Assessment of Contributions Plan No.18 –
Bella Vista and Kellyville Station Precincts:
Technical Paper

Draft Report

September 2021

Figure 7.1 Assumed residential development path for CP18

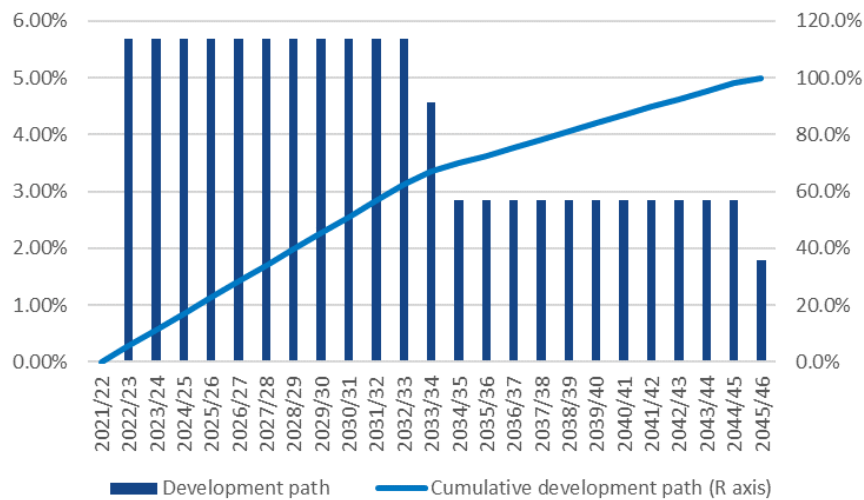
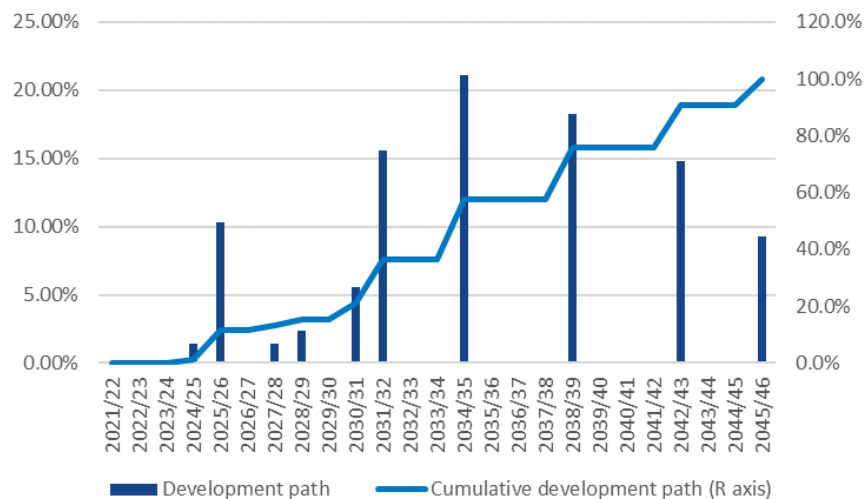
The most recent development paths provided are presented in Figure 7.1 and Figure 7.2 below. These show that while residential development is expected to occur each year, non-residential development will occur in stages, with most occurring in the second half of the plan. We consider that these development paths are reasonable and recommend that the council update its NPV models to reflect the revised development paths.

- 13. Update the development paths in the residential and non-residential NPV models, and in Table 1 of CP18, to reflect post-exhibition dwelling and yield amendments.
